UK-11913-1-26

BGCC 1<sup>st</sup> Floor Renovation

ADDENDUM #4

**Addendum Number Four**

01 ENLARGED FIRST FLOOR PLAN - AREA 'A1'  
A4.1.A1 1/4" = 1'-0" NORTH

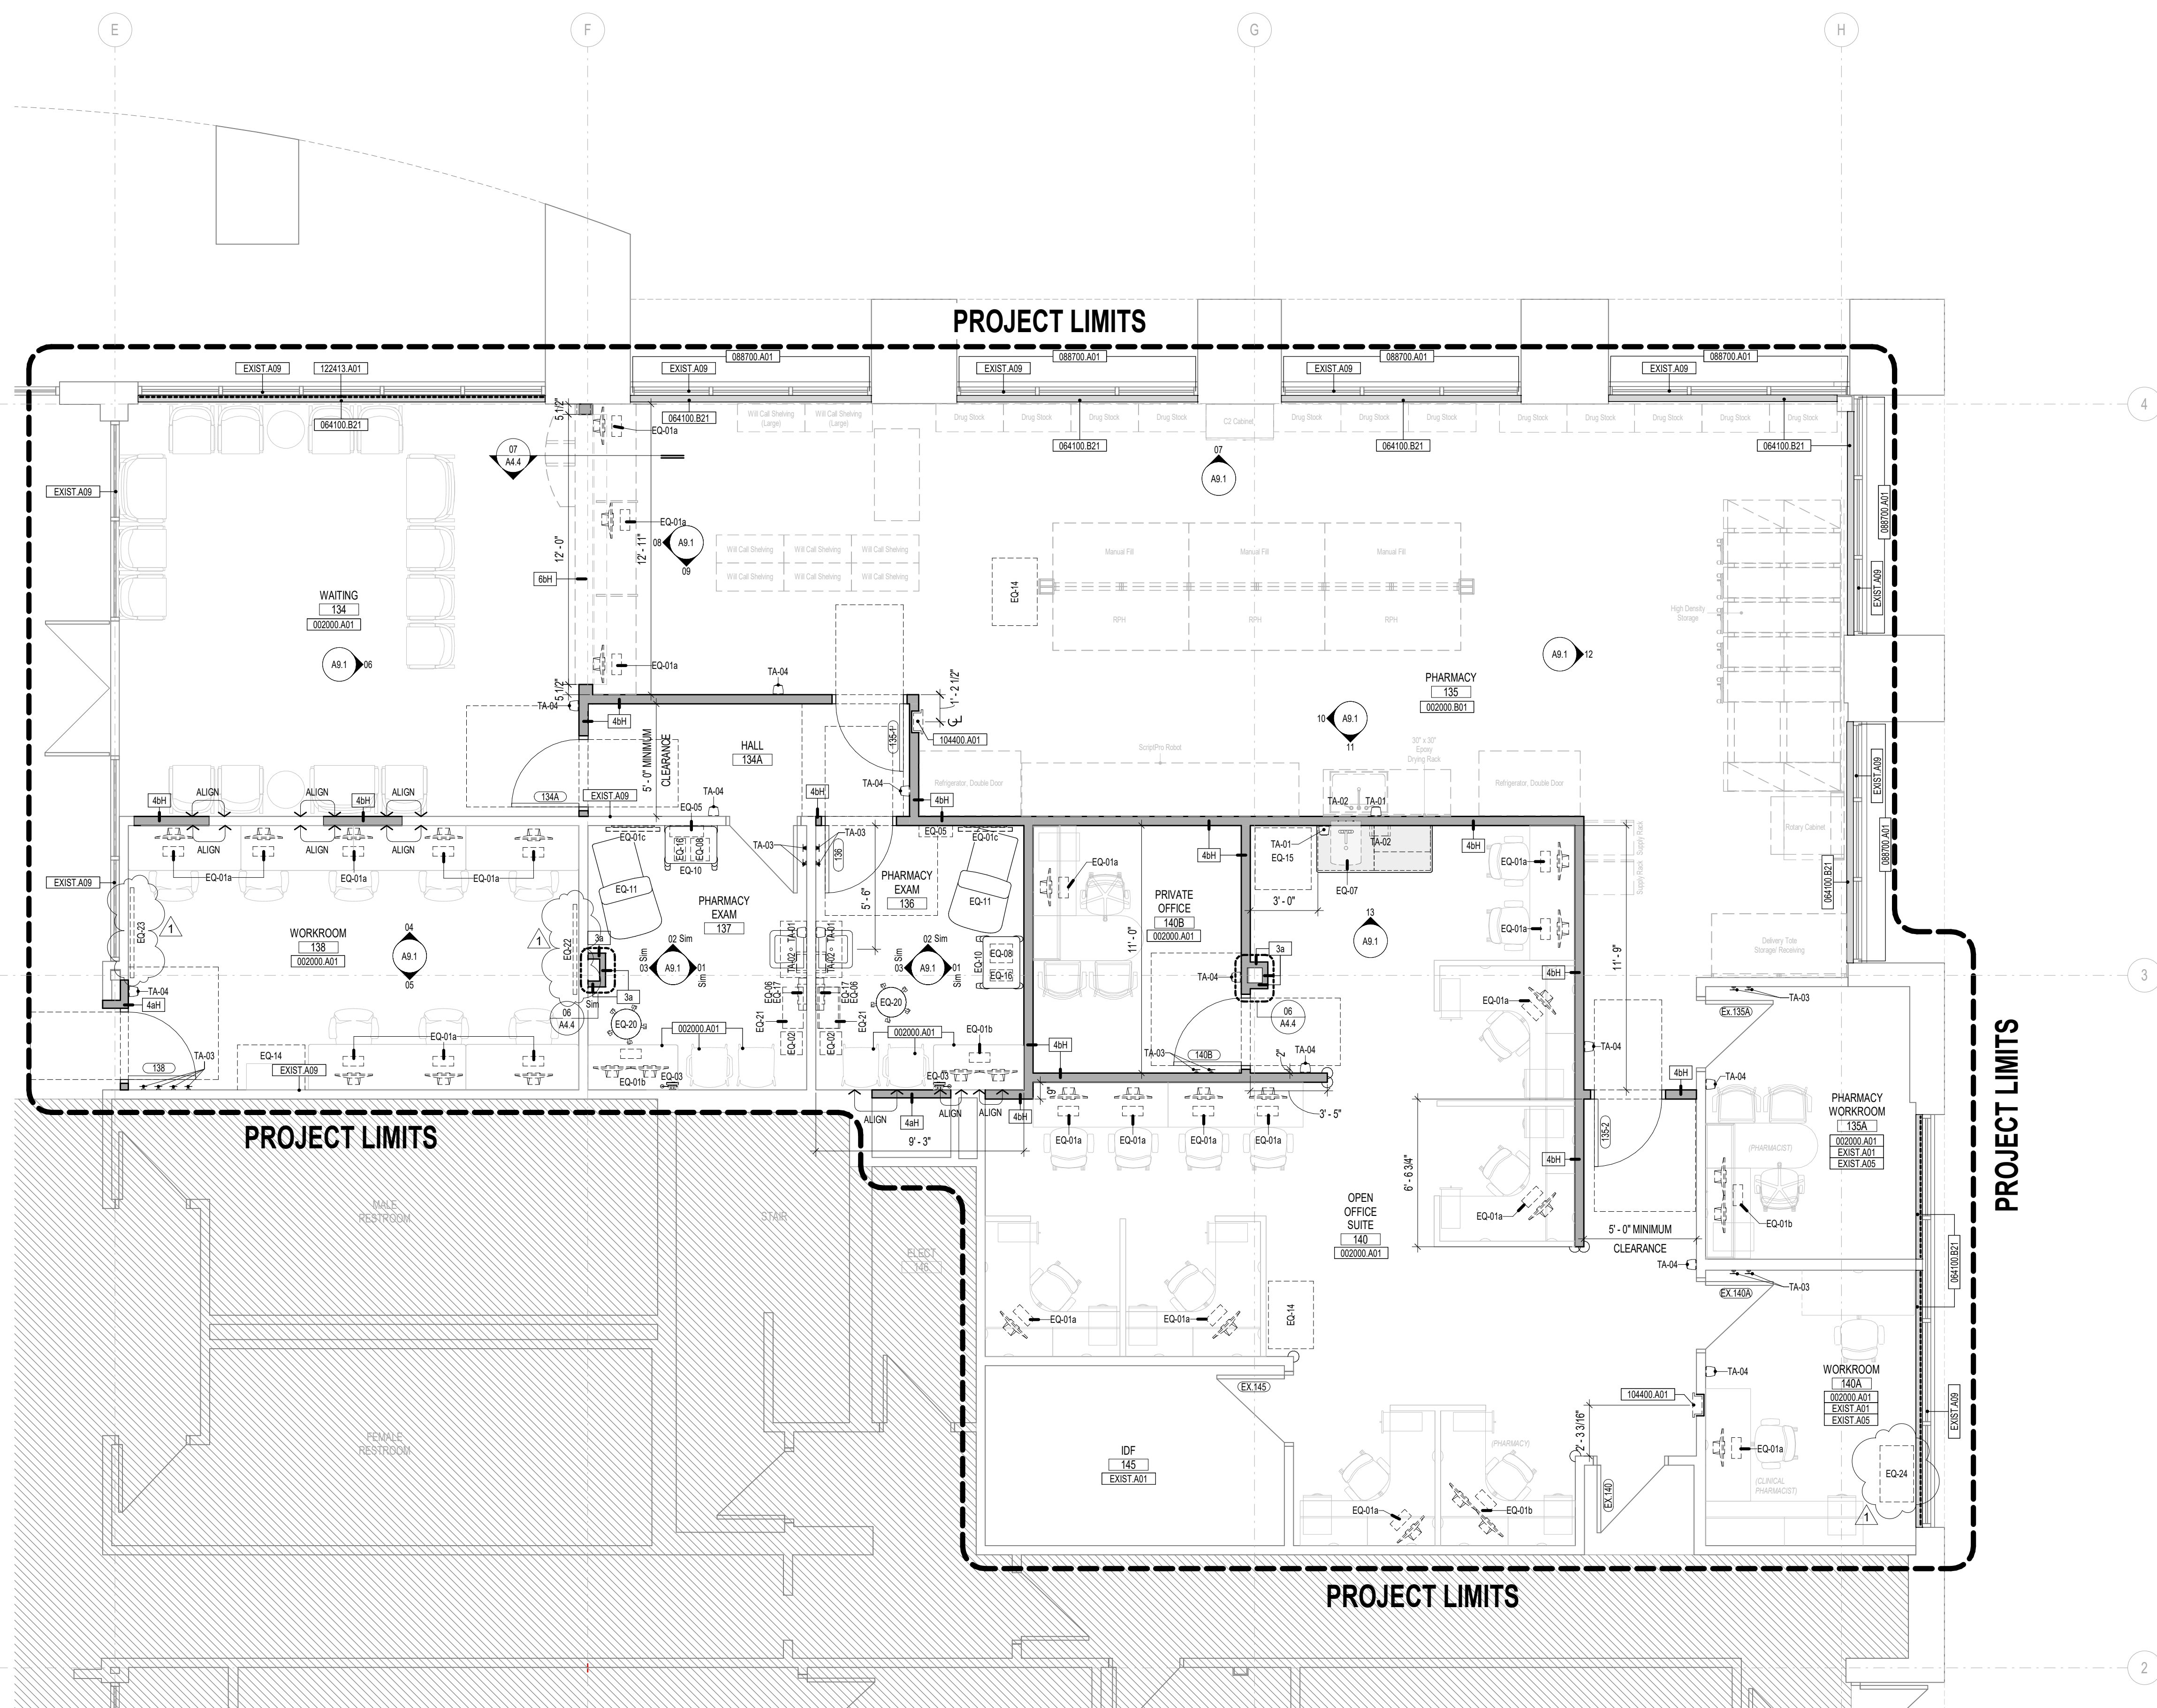
**1.05 Reference:** *A4.1.A1 – ENLARGED FIRST FLOOR PLAN – AREA ‘A1’*

**Clarification:** Added window film keynote at location of existing storefront in response to Bidder Question #17.

**Clarification:** Clarified the locations of tackboard/whiteboards in response to Bidder Question #9.

**01** ENLARGED FIRST FLOOR PLAN - AREA 'A2'  
A4.1.A2 1/4" = 1'-0" NORTH

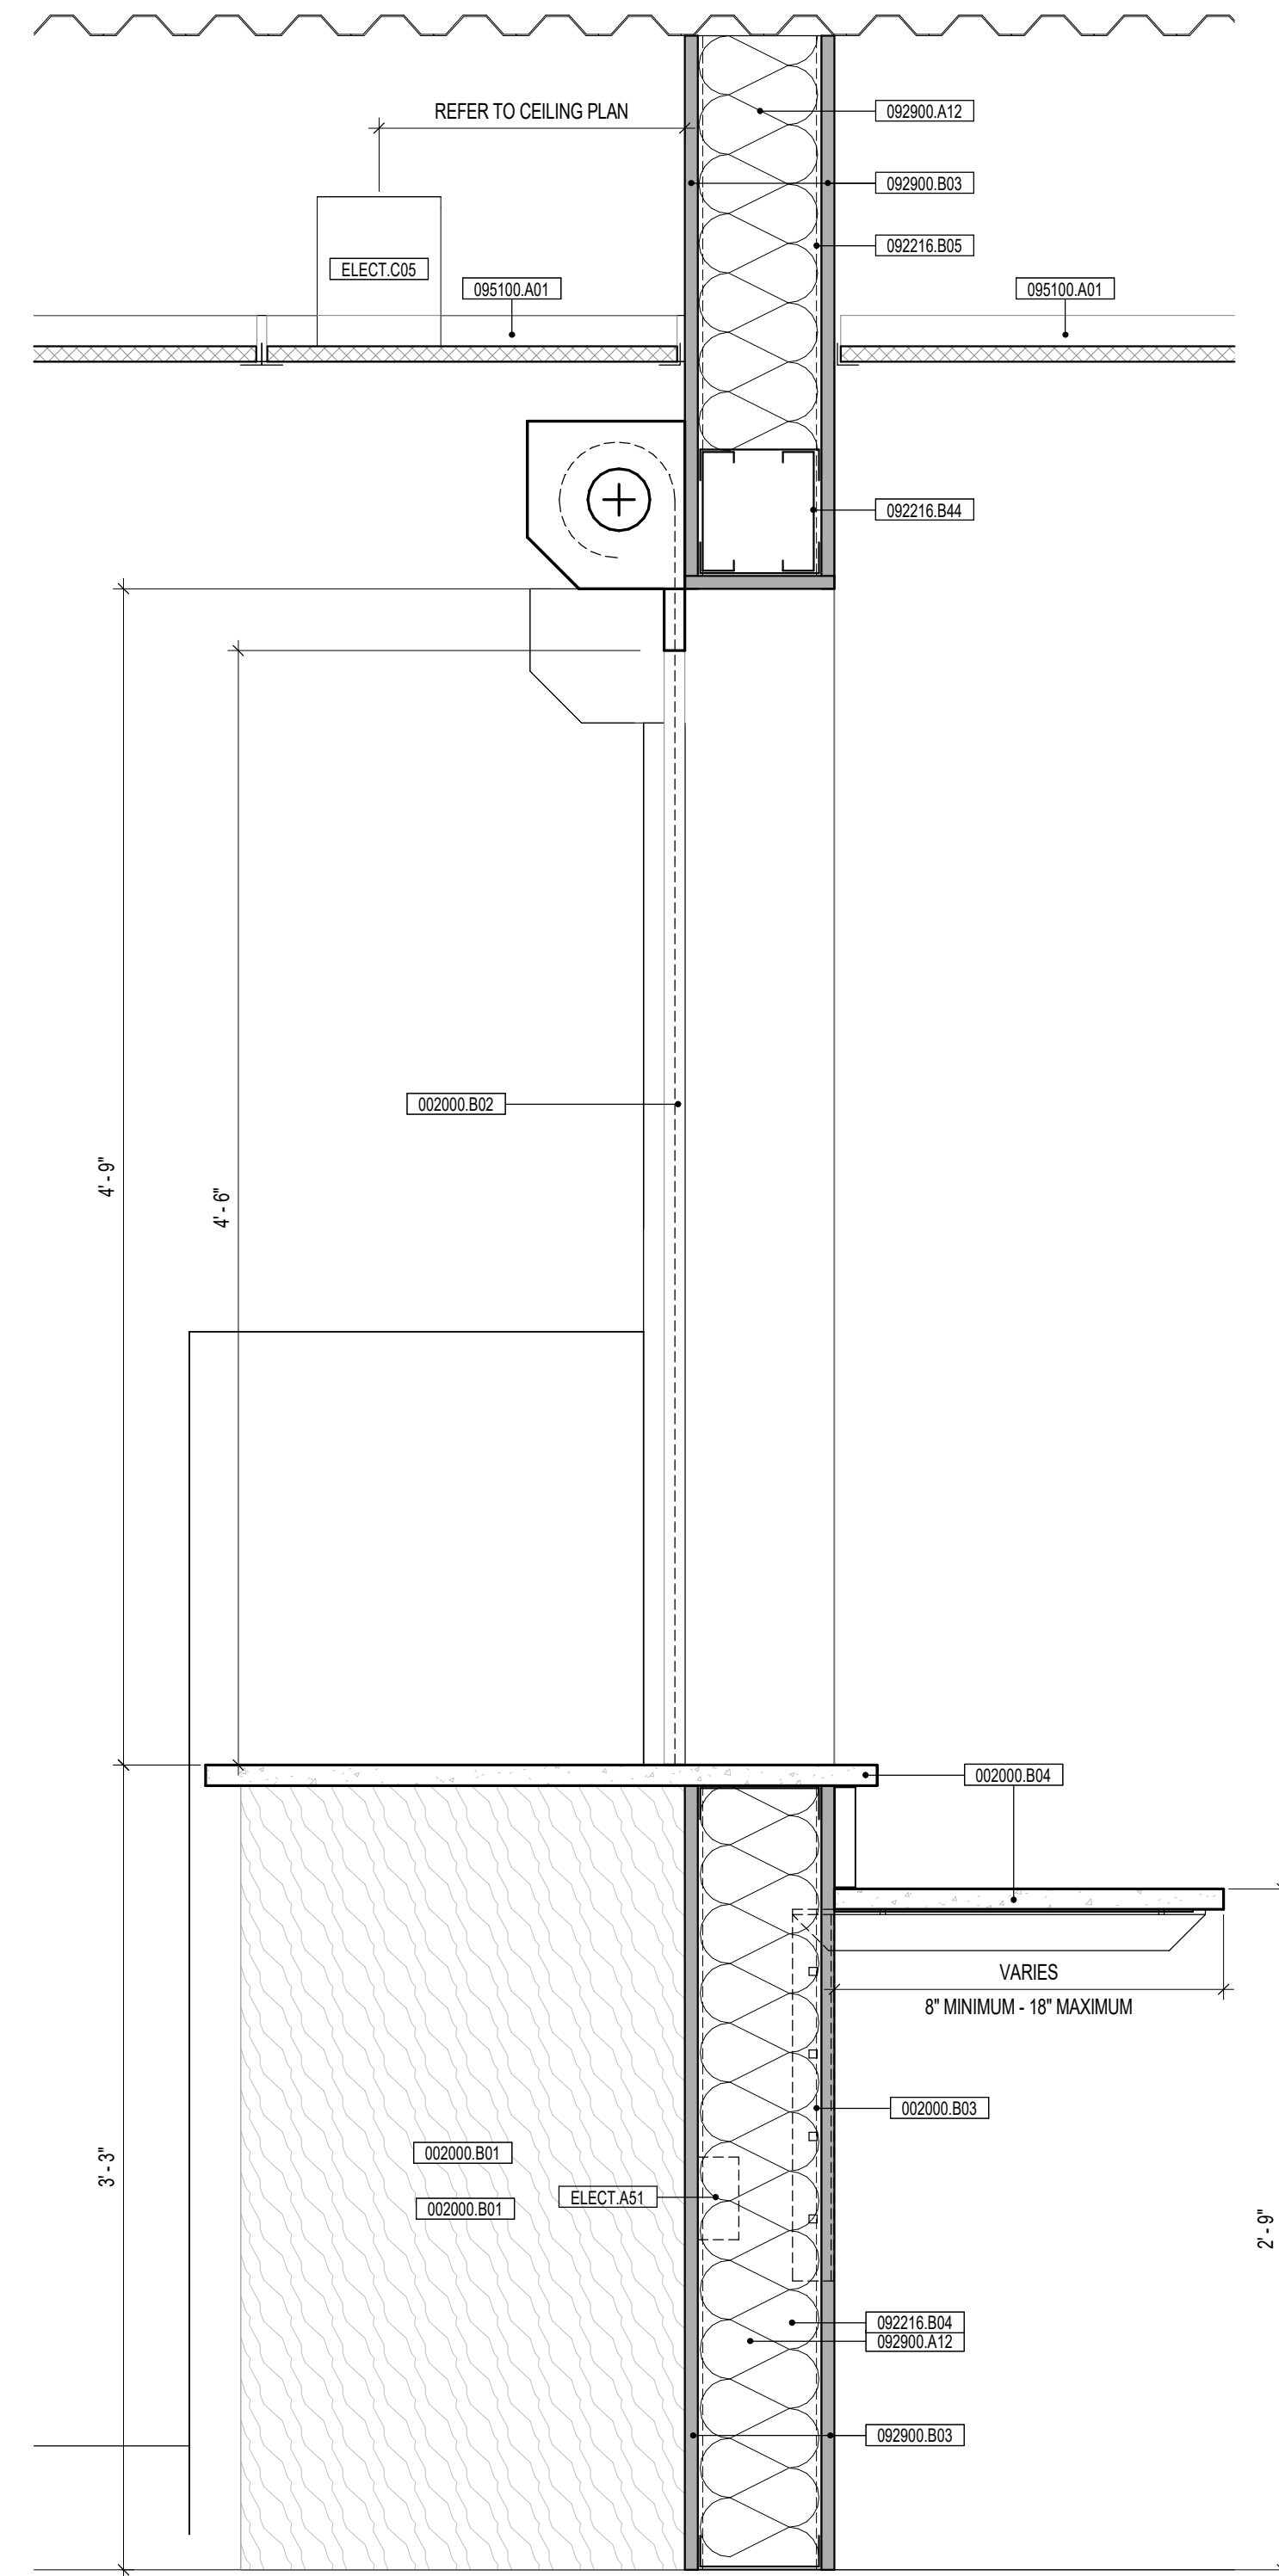
- 1.06 Reference:** *A4.1.A2 – ENLARGED FIRST FLOOR PLAN – AREA ‘A2’*
- Clarification:** Clarified the locations of tackboard/whiteboards in response to Bidder Question #9.
- Clarification:** Added EQ-24 to Workroom 140A, previously included as part of casework.
- 
- 1.07 Reference:** *A4.4 – PLAN & SECTION DETAILS*
- Clarification:** Added window film keynote at location of existing storefront in response to Bidder Question #17.
- 
- 1.08 Reference:** *A10.1 – OPENING & EQUIPMENT SCHEDULES*
- Clarification:** Added EQ-23: Tackboards and EQ-24: Steelcase Cabinet.
- 
- 1.09 Reference:** *ID1.1 – COMPOSITE FIRST FLOOR FINISH PLAN*  
*ID1.1.A1 – ENLARGED FINISH PLAN – AREA ‘A1’*  
*ID1.1.A2 – ENLARGED FINISH PLAN – AREA ‘A2’*
- Clarification:** Revised finish legends to specify ¼” thickness at WP2 in response to Bidder Question #12.
